PARK CITY MUNICIPAL CORPORATION
ADMINISTRATIVE PUBLIC MEETING MINUTES
PLANNING DEPARTMENT
<https://us02web.zoom.us/j/88167820277>
April 3, 2025

64 Chambers Avenue – Historic District Design Review – PL-24-06360 – The Applicant Proposes to Construct a Rear Addition to a Landmark Historic Structure in the Historic Residential - 1 Zoning District.

516 Marsac Avenue – Extension of Historic District Design Review – PL-25-06423 – The Applicant Proposes to Construct a 147-Square-Foot Addition to an Existing Non-Historic Structure in the Residential - 1 Zoning District.

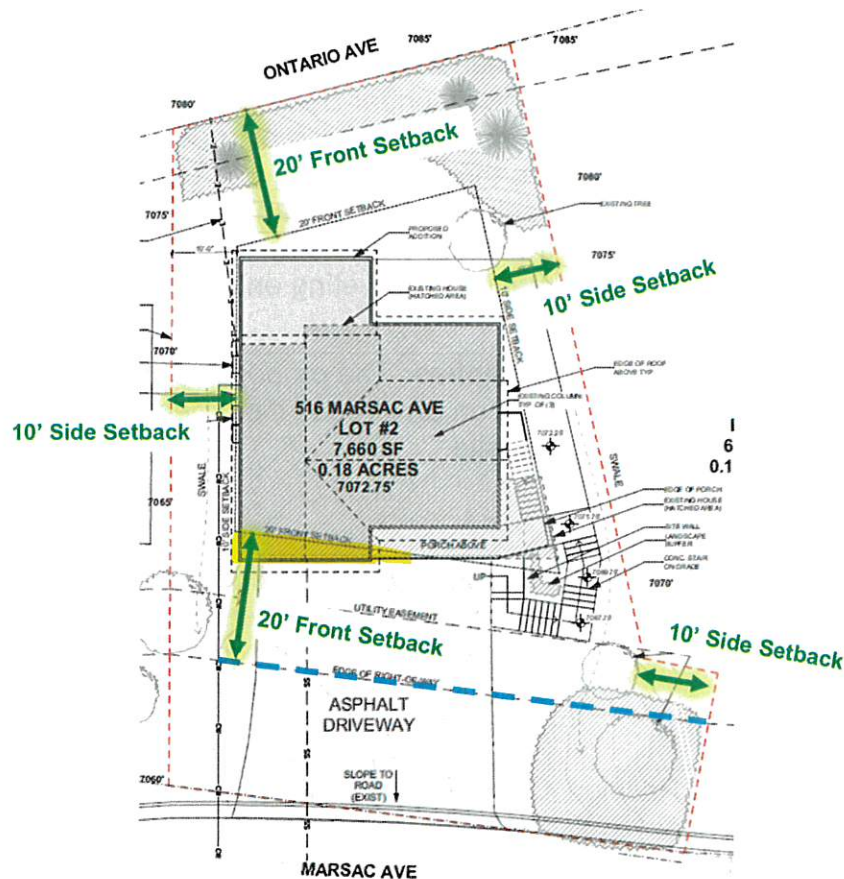
9. As the Lot has six sides, and fronts two public Rights-of-Way, the Planning Director determined the Setbacks for the Lot, illustrated below:
